Independent Hearings Panel

Christchurch Replacement District Plan

MINOR CORRECTIONS TO DECISIONS

Further corrections to chapters and planning maps in response to an application from the Christchurch City Council dated 19 May 2017

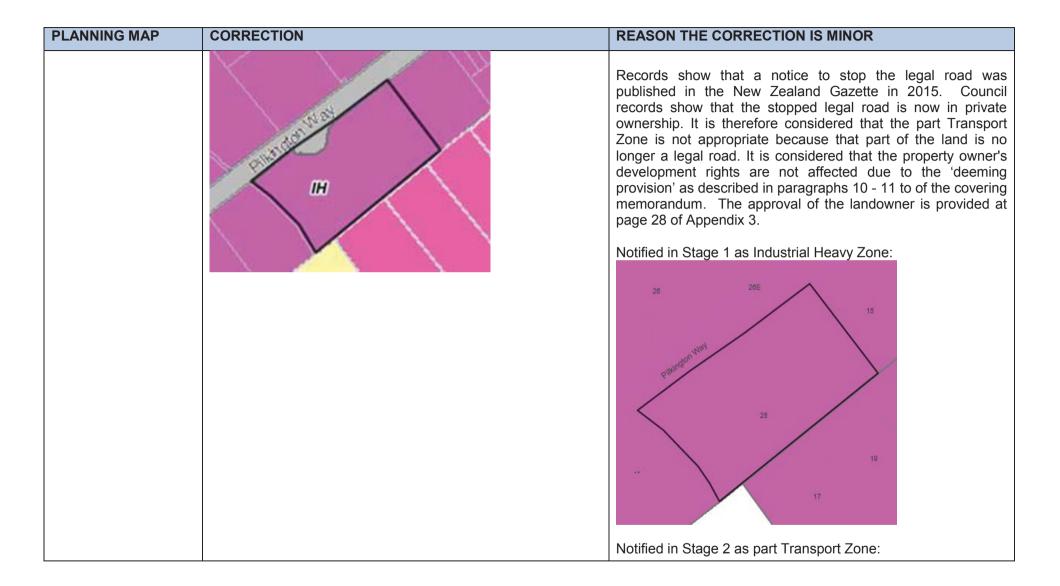
PLANNING MAP	CORRECTION	REASON THE CORRECTION IS MINOR
Planning Map 37	Amend zoning of the entire property at 455R Blenheim Road from part Commercial Mixed Use and part Transport Zone to Transport Zone. This property is shown outlined black in the map below: Blenheim Rd	This strip of land is owned by Christchurch City Council and runs along Curletts Road onto Blenheim Road. It was notified in Stage 1 as Industrial General Zone, and in Stage 2 as part of the Transport Zone. Submissions in Stage 1 by Grant Nelson (#317), 7990 Limited (#1086) and Peebles Group Ltd (#1195) sought to rezone land fronting Blenheim Road as Commercial Retail Park. In Decision 11, ' <i>properties zoned</i> <i>Industrial Heavy or Industrial General in the Notified Version in</i> <i>the Blenheim Road area – between Blenheim Road (to the</i> <i>north), the Railway Line (to the south), Whiteleigh Avenue (to</i> <i>the east), and Main South Road (to the west); and to the north</i> <i>of Blenheim Road</i> '' were rezoned to Commercial Mixed Use. Later in time, Decision 12 confirmed the Transport zoning, as notified in Stage 2.

447	However, the boundary of the Transport Zone was made in error by following the bridge edge, rather than the entire parcel of land. It is considered appropriate to remove the part Commercial Mixed Use Zone and adjust the boundary of the Transport Zone to follow the entire parcel instead of following the bridge edge because this entire parcel of land is held by Council for legal road and transport purposes only. The Council as landowner supports this zoning boundary adjustment. The approval of the owner of 1/455 Blenheim Road is currently being sought.
Planning Map 37	Amend the zoning of 25 Pilkington Way (outlined in black below) by removing the part Transport Zone and replacing it with Industrial Heavy Zone.	The property owned by Pilkington Way Limited at 25 Pilkington Way, Sockburn was notified in Stage 1 as Industrial Heavy and in Stage 2 as part Transport Zone. Decision 11 confirmed the Industrial Heavy Zone while Decision 12 (later in time) confirmed the part Transport Zone. There were no submissions in either Stage 1 or Stage 2 against this property.

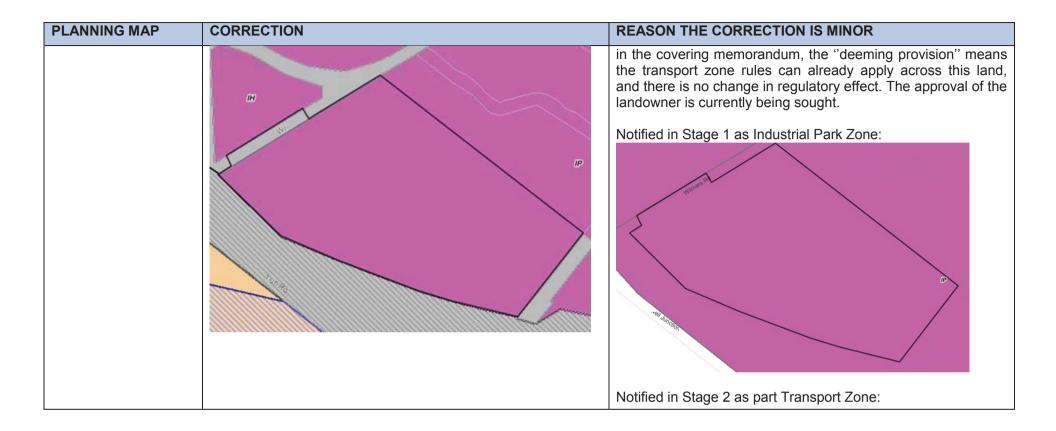
PLANNING MAP	CORRECTION	REASON THE CORRECTION IS MINOR
Planning Map 44	Amend the zoning of 50 Wilmers Road (outlined in black below) by removing the part Transport Zone and replacing it with Industrial Park.	The property owned by Meadow Mushrooms at 50 Wilmers Road, Hornby was notified in Stage 1 as Industrial Park and in Stage 2 as part Transport Zone. Decision 11 confirmed the Industrial Park Zone while (later in time) Decision 12 confirmed the part Transport Zone. There were no submissions in either Stage 1 or Stage 2 against this property.
		Records show that a notice to stop the legal road was published in the New Zealand Gazette in 2015. Council records show that the stopped legal road has been amalgamated with 50 Wilmers Road. For the reasons set out

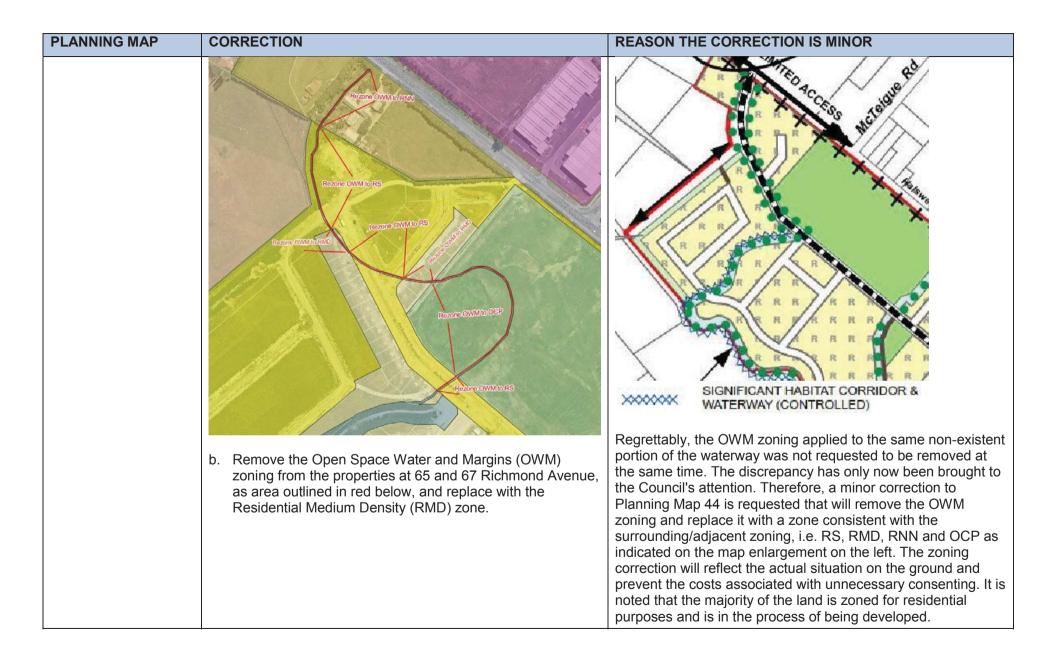
PLANNING MAP	CORRECTION	REASON THE CORRECTION IS MINOR
		Jores
Planning Map 44	 Remove the Open Space Water and Margins (OWM) zoning from the area indicated with a red line below and replace with the surrounding/adjacent zoning i.e. Residential Suburban (RS), Residential Medium Density, Residential New Neighbourhood (RNN) and Open Space Community Park (OCP) as indicated. 	During the hearing for Chapter 6 General Rules, Ms McLaughlin presented evidence ² with regard to a request by Fulton Hogan and Mr Olive (the submitters) to remove a portion of the 'Upstream Waterway' classification from that part of Knights Stream between Richmond Ave and Halswell Junction Road. She supported the relief sought on the basis that there was no waterway in the area indicated, therefore the classification was unfounded. Such amendment was also consistent with the Outline Development Plan in Appendix 8.10.6, where Knights Stream is shown as stopping on the south side of Richmond Avenue.

PLANNING MAP	CORRECTION	REASON THE CORRECTION IS MINOR
		A closer scrutiny of the land/waterway in the area immediately south of the future extension of Richmond Avenue revealed that both the 'Upstream Waterway" classification and the OWM zoning should also be removed from the narrow portion of the OWM zone extending over residential properties at 65 and 67 Richmond Avenue (refer to the map in (b.) on the left). The OWM zoning should be replaced with RMD.
	Ber Abb Ber Aussiand Dir Start Dir S	The narrow "leg" of the waterway does not exist on the ground and the headwaters of the stream start within the adjacent wider part of the OWM zone. Any residual water seepage from the underground springs further north are directed to the stream through a pipe, under Richmond Avenue, which comes out directly into the wide portion of the OWM zone.
		The removal of the zoning and waterway classification is considered to be a minor correction which removes a defect in the Plan and simplifies the zoning and rules affecting the newly subdivided residential properties at 65 and 67 Richmond Avenue. The RMD zoning will reflect the intended use of the sites.

Planning Map 48	Rezone a small area of land at the van Asch Road frontage of	The piece of land outlined in red is designated by the Minister
	the Van Asch Deaf Education Centre from Transport zone to	of Education as part of L105 van Asch Deaf Education Centre

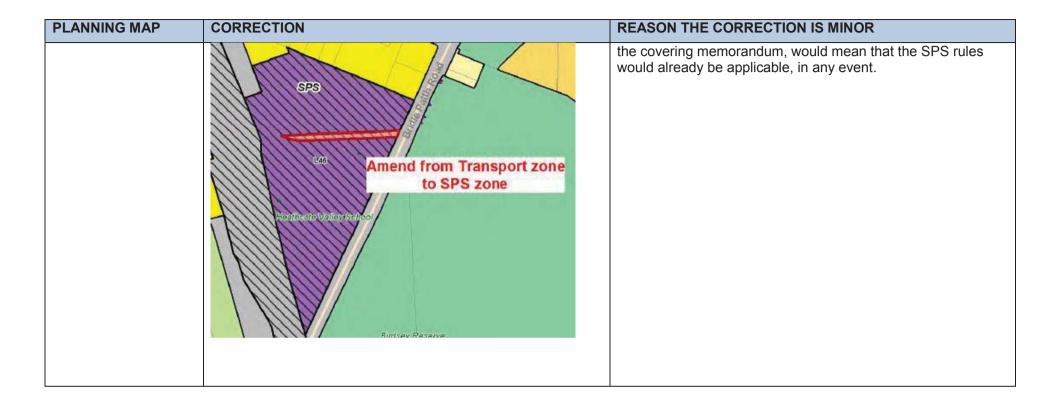
PLANNING MAP	CORRECTION	REASON THE CORRECTION IS MINOR
	SP School zone, to correspond with the designation.	and is owned by the Crown, for the "Institute for Deaf Mutes". It has been inadvertently zoned as Transport zone because it is in a separate title to the remainder of the school site. However it is not owned by the Council and is not used for road. Physically, it forms part of the grassed open space and playing fields of the van Asch School. The Council considers that zoning of the land as Transport Zone is a minor defect in the Planning Maps. The Ministry of Education has indicated that is supports this amendment to SPS zoning and written approval is expected in the near future. No other landowners are considered to be affected and the deeming provision explained in the covering memorandum, is applicable.
Planning Map 47	Rezone wedge of land through centre of site which is designated by the Minister of Education for Heathcote School, from Transport zone to SP Schools zone.	This thin wedge of land was gazetted in 1979 (p457) for a State Primary School, and is owned by the Crown. It is an integral part of the school site, is not owned by the Council, is not used as road (it forms an east-west slice of land across the school's open space and playing field area), and it is a defect in the Planning Maps that it was zoned Transport. It appears that the site was inadvertently zoned as road because it was a residual area, which is not part of the title for the remainder of the school site. The Ministry of Education has indicated that it supports this amendment to SPS zoning and written approval is expected in the near future. No other landowners are affected by this change, and the deeming provision covered in

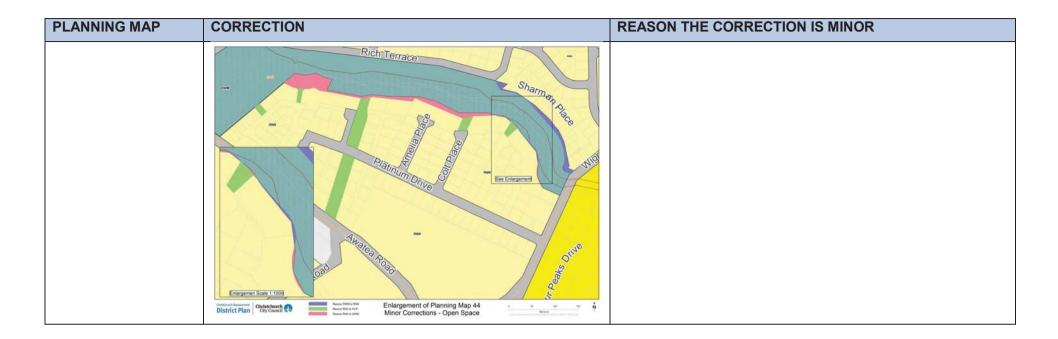
20 Sharman Place, Lot 42 DP 489410	OWM and RNN	RNN	already been built. Therefore the correction will not hav material effect on the owners' ability to develop the land.
	22 Sharman Place, Lot 43 DP 489410	OWM and RNN	RNN	
	24 Sharman Place, Lot 44 DP 489410	OWM and RNN	RNN	
	26 Sharman Place, Lot 45 DP 489410	OWM and RNN	RNN	
	28 Sharman Place, Lot 46 DP 489410	OWM and RNN	RNN	
	29 Sharman Place, Lot 50 DP 489410	OWM and RNN	RNN	
	31 Sharman Place, Lot 49 DP 489410	OWM and RNN	RNN	
	32 Sharman Place, Lot 48 DP 489410	OWM and RNN	RNN

PLANNING MAP	CORRECTION			REASON THE CORRECTION IS MINOR
	 B. Rezone the newly vested recreation reserves from RNN to OCP as per the list and the Planning Map 44 below (light green shaded areas). 			
	Address	Current zoning	Correct Zoning	
	RNN to OCP rezoning		¥	
	27R Dow Square, Lots 101 & 102 DP 479291	RNN	OCP	
	2R Vashley Bay Place, Lot 54 DP 477367	RNN	OCP	
	14R and 16R Platinum Drive, Lots 55 and 61 DP 477367	RNN	OCP	
	18R Colt Place, Lot 151 DP 479119	RNN	OCP	
	29R Edwin Ebbett Place, Lot 66 DP 482951	RNN	OCP	
	* Refer to enlargement maps below details of properties/parts of proper		view of the

* Planning Map 44 enlargements

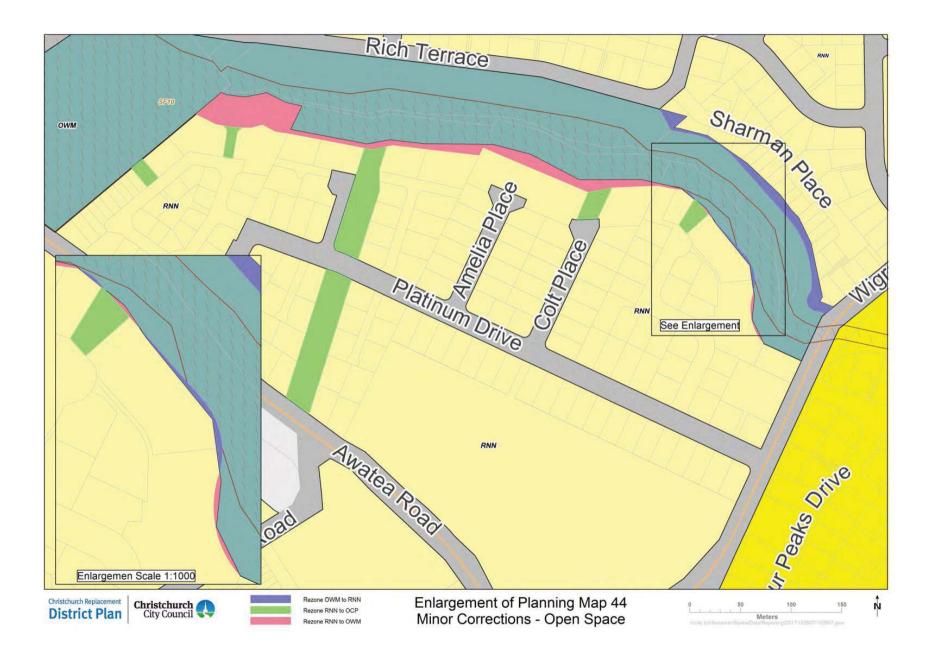
a. RNN and OWM zone boundaries adjustments needed in the Sharman Place/Erling Zeisler Lane area
